Basalt Waste Isolation Project  
Comments on  
Exploratory Shaft Drilling and Sealing

ENGINEERS INTERNATIONAL, INC.

Engineers International, Inc. (EI) has critically reviewed these documents with respect to four major areas of concern to the NRC:

Figure 1. Stratigraphy and mud losses, found in Borehole RRL-2 (from information provided in DOE ref. 10)

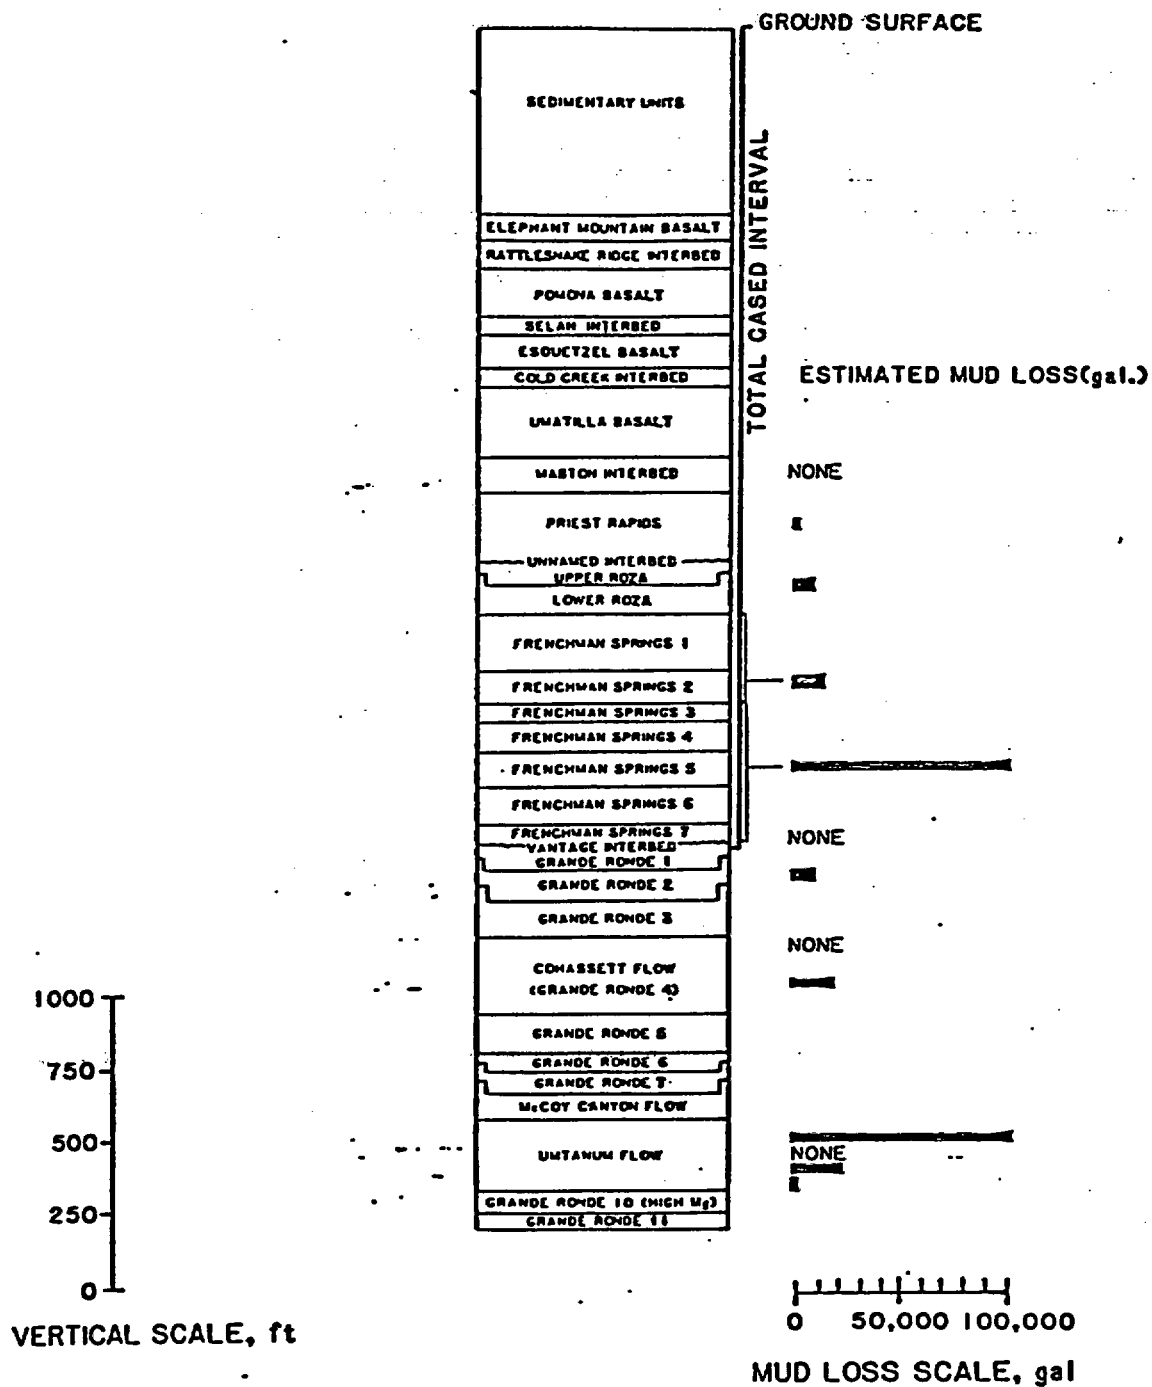
According to the Mud Loss Summary in the RRL-2 report, over 300,000 gallons of drilling mud were lost during the drilling of the principal borehole. Mud loss is an approximate indicator of formation permeability, and the Mud Loss Summary presents the quantities of mud that were assumed to be lost to each of the permeable formations encountered. Most significant is the large quantity of mud loss attributed to the Umtanum flow. Correlation between the mud losses in RRL-2 and other boreholes apparently has not been made. In addition, the RRL-2 report does not indicate how the mud losses within individual formations were determined or over what time span the losses occurred.

Hydrologic testing in RRL-2 indicates that permeabilities in most tested zones were slightly higher than had been estimated previously. There is no mention in the report regarding what effect the considerable mud losses might have had on subsequent permeability measurements. Accumulated clay and other drill mud materials could tend to decrease fracture permeability as determined by downhole testing (Greenslade et al, 1981). Figure 1 shows the location of the severe mud loss zones and the quantities of mud lost.

Figure 4. Schematic Dual-String circulation system (after Lackey, 1982)

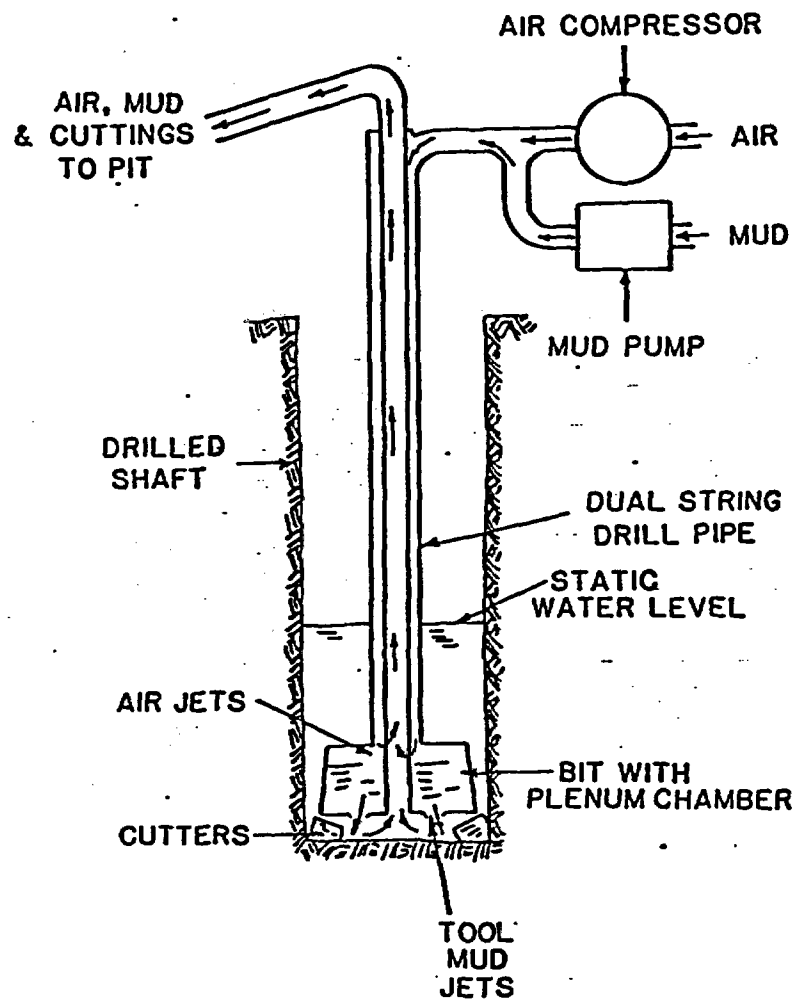
Where excessive mud losses are anticipated, the dual-string circulation technique may be more effective. With the dual-string circulation technique, shown in Figure 4, mud mixed with compressed air travels to the drill bit through the annulus between the outer drill pipe and the inner string and returns up the inner string. A major advantage of this system is that the hole need not be kept completely filled with fluid, reducing the head driving the mud into the formation. Lackey (1982), feels that the dual-string system does a better job of cleaning the hole. However, for deep holes, high pressure compressed air is required to overcome losses and the hydrostatic head. This requires the use of large capacity compressors.
